CIVIL ENGINEERING DEVELOPMENT APPLICATION REPORT
RESPONSE TO DOUGLAS SHIRE COUNCIL RFI
Application no: CA 2025_5878/1

PROPOSED RESORT DEVELOPMENT

18 OASIS DRIVE, WONGA BEACH, QUEENSLAND

Project No: 21342

Title:
Bus Turning Circles
14.5 m Rigid Bus

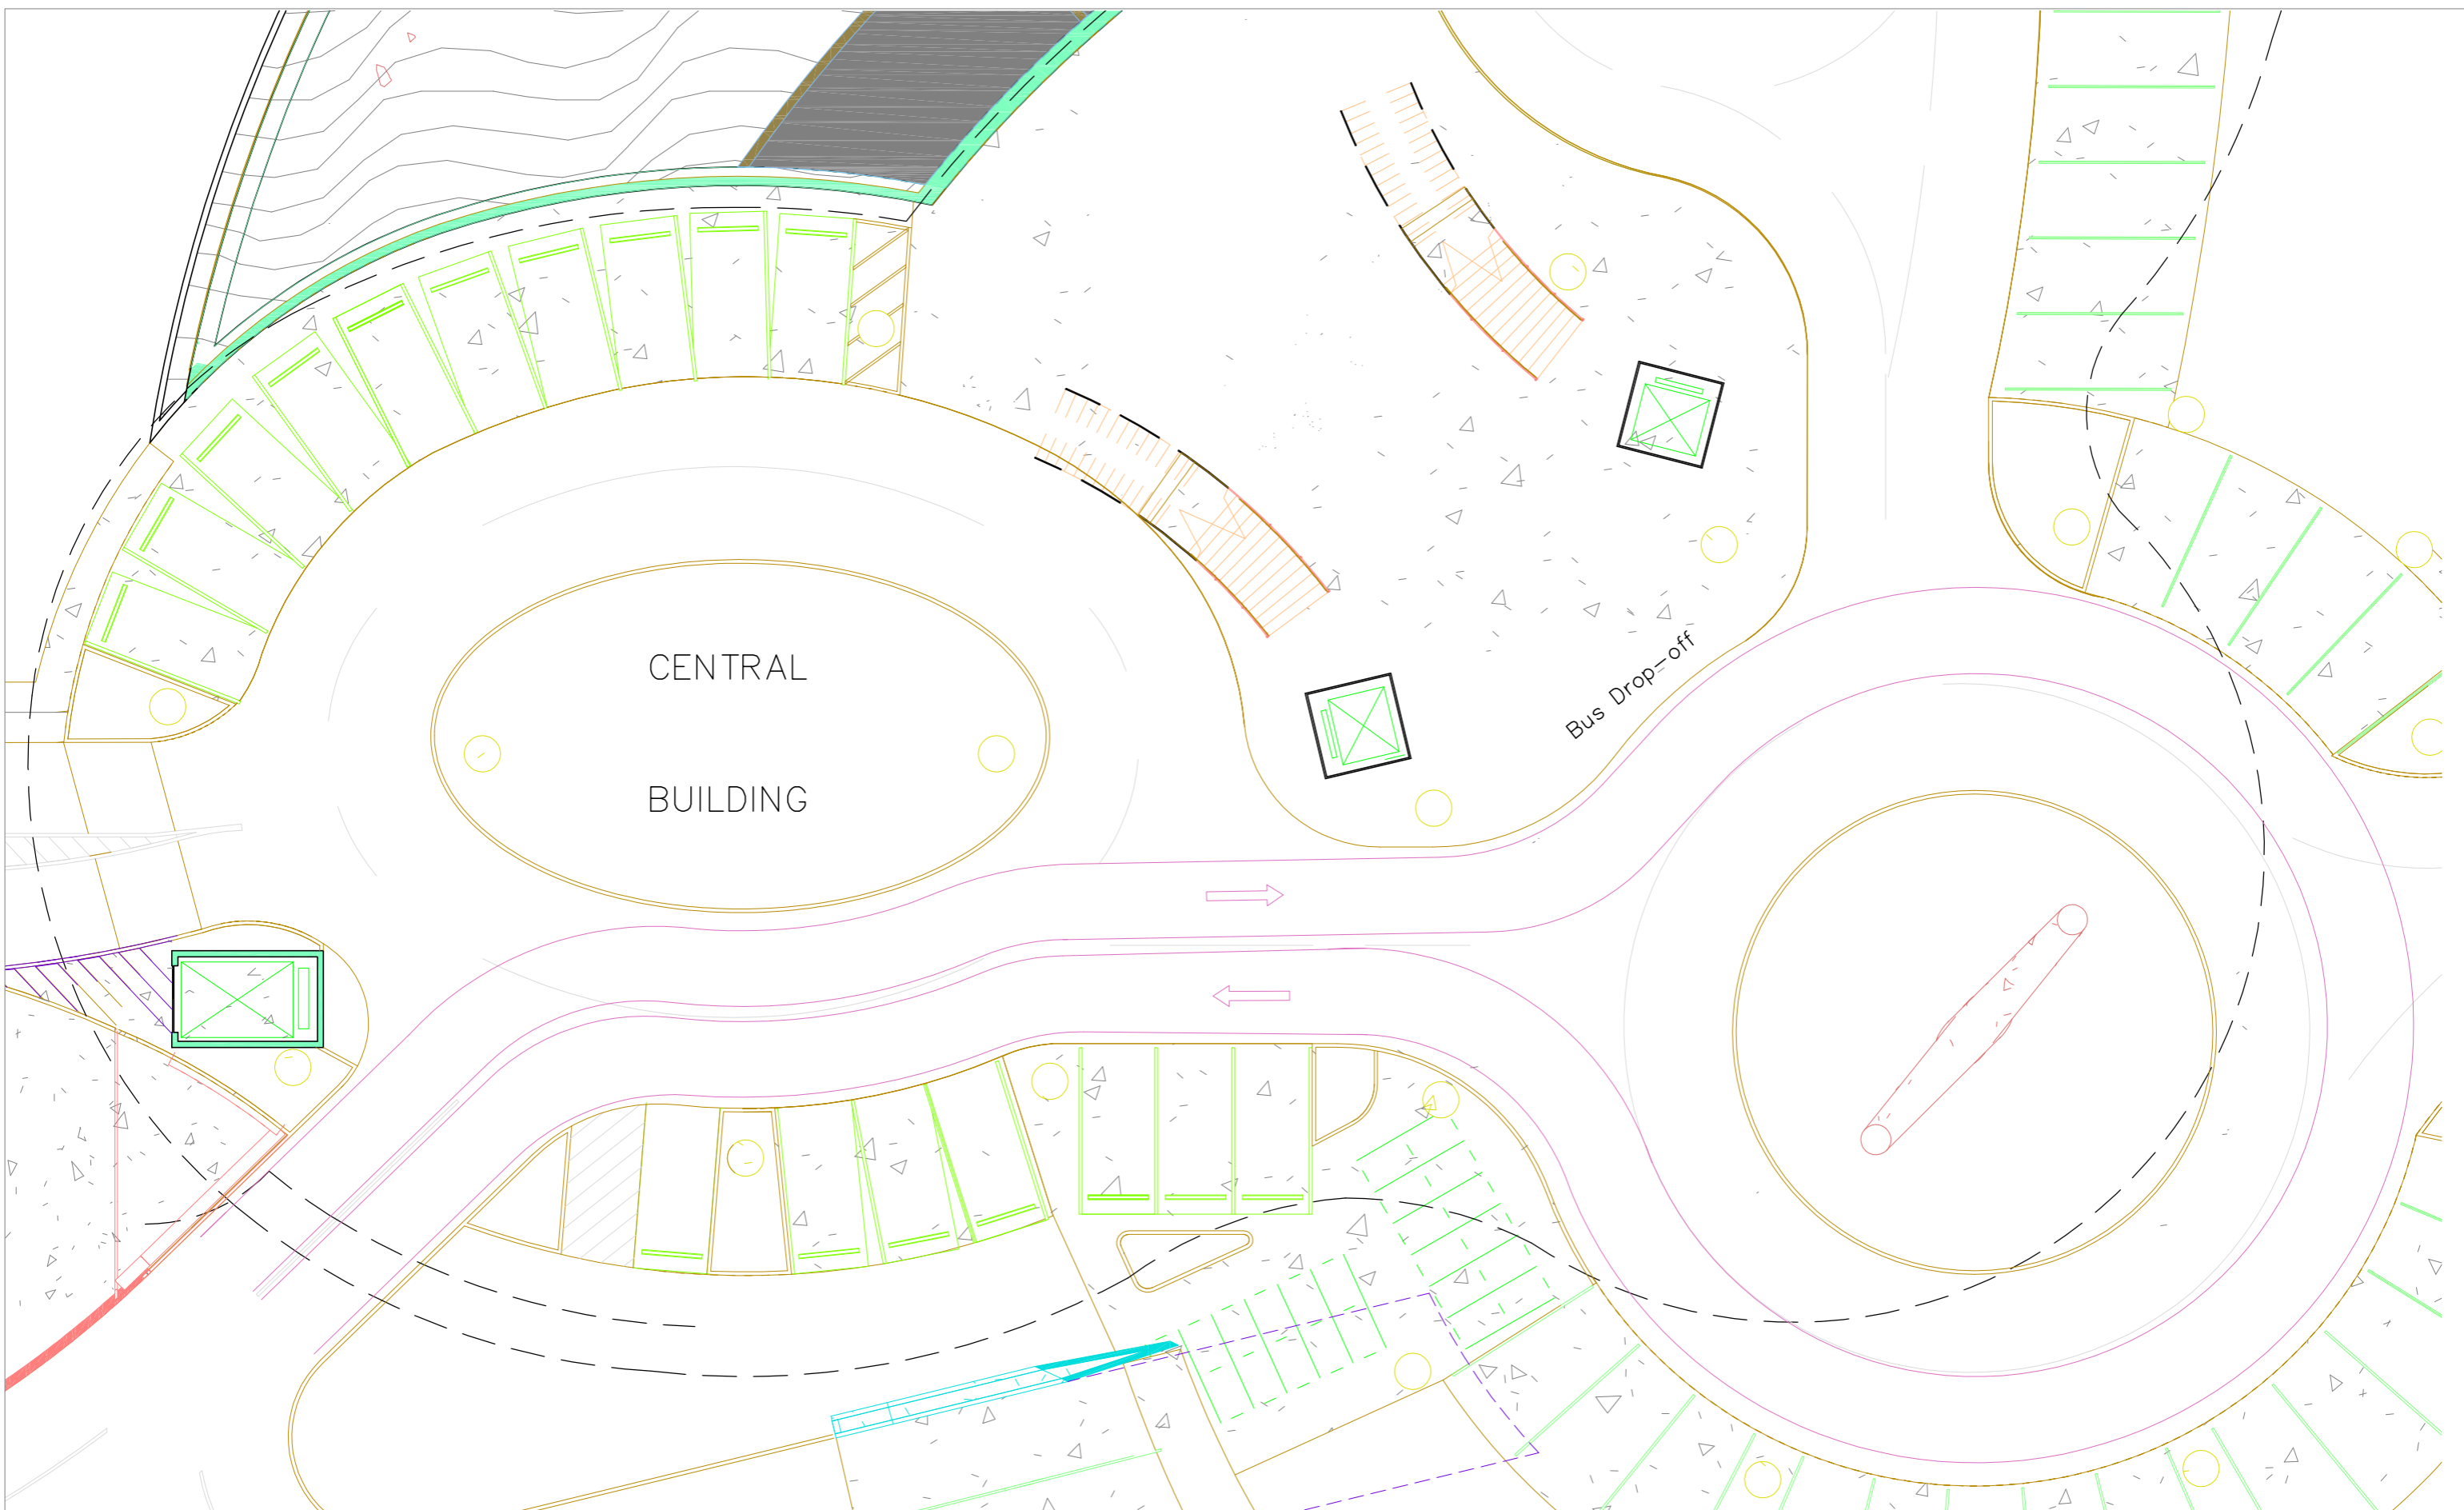
The inclusion of a dedicated on-site bus drop-off and turning area substantially improves operational efficiency and safety outcomes.

- Coach turning movements – Catered for within the main building
 - Tourist driver unfamiliarity – This is in a low speed environment with good sightlines and a very straight forward road network with only one turn after leaving the Mossman-Daintree road. Good signage makes this simple and safe.

Scale:	1:500 @ A1	Job No:	21342
Date:	Apr. 2026	Drawing:	C01
CAD File:	21342 - Overall Plan_Undercroft	Checked:	th
Drawn:	th	Revision:	B

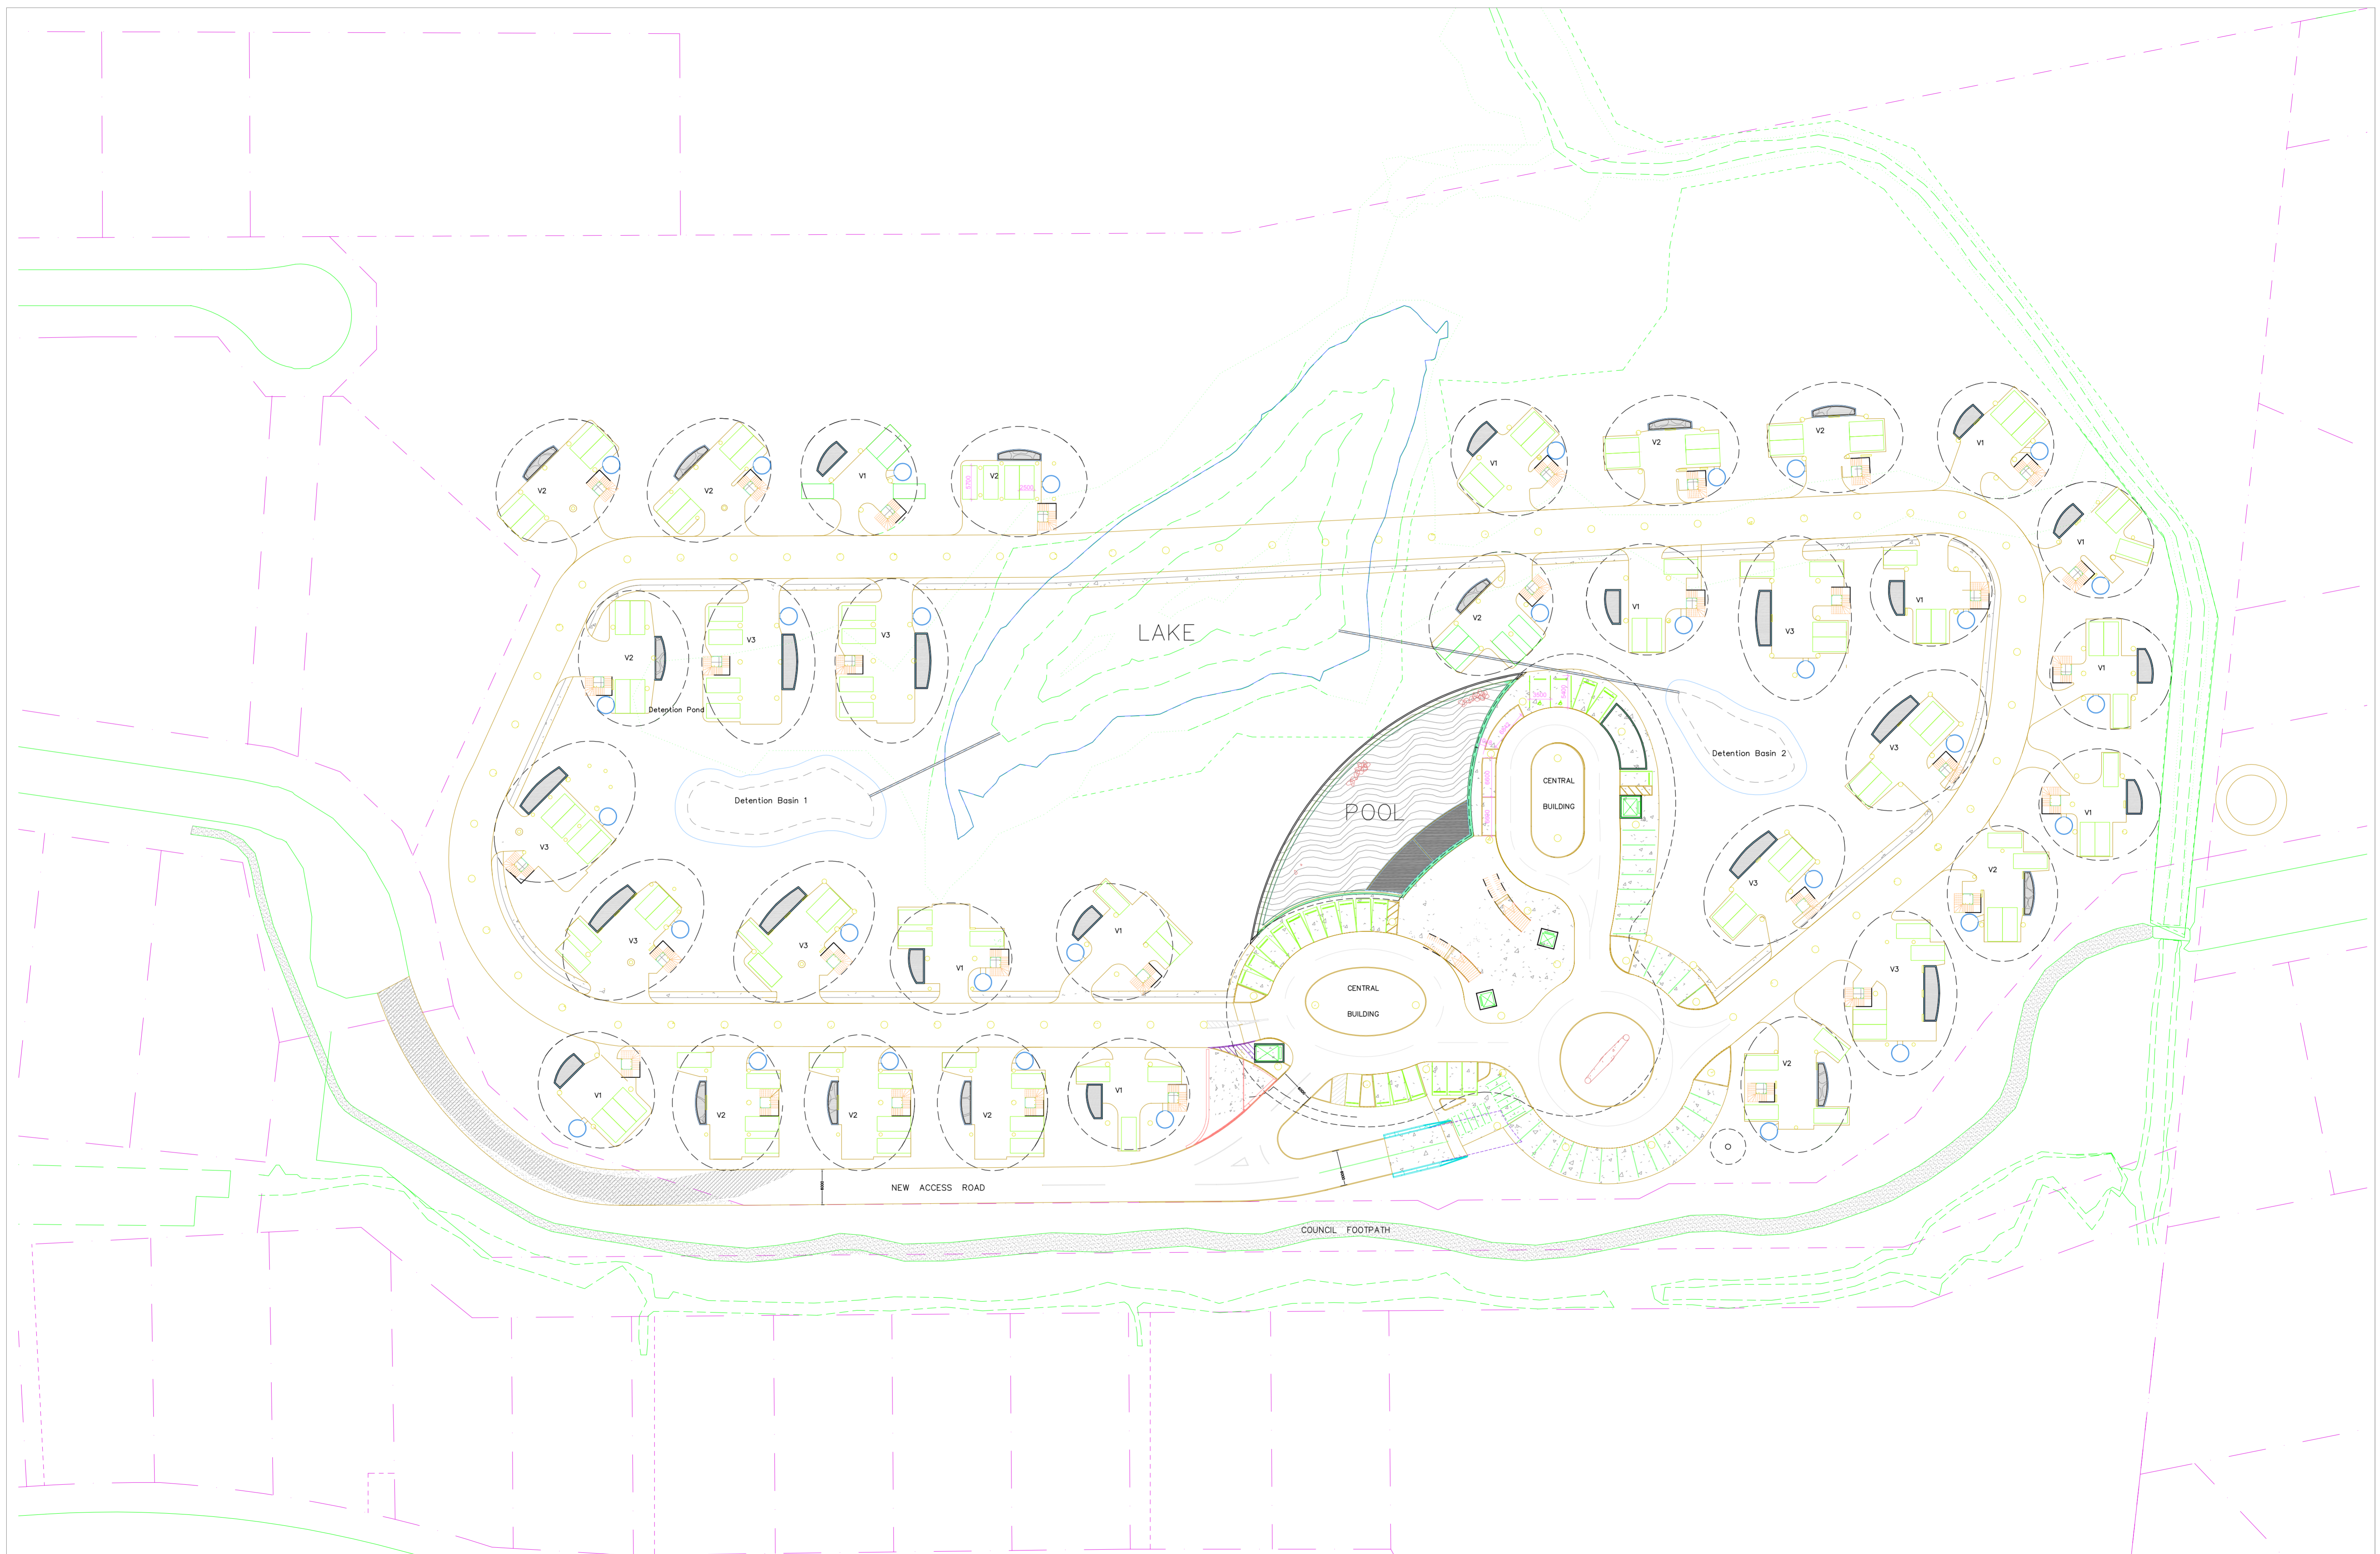
The carparks and circulation at ground level for the resort have been redesigned by a Civil Engineer in this office. They now comply with **AS1890.1-2004 Parking facilities Part 1: Off-street Car Parking**

These changes are now shown on both the Engineering drawing C01 as well as the updated Architectural drawings.
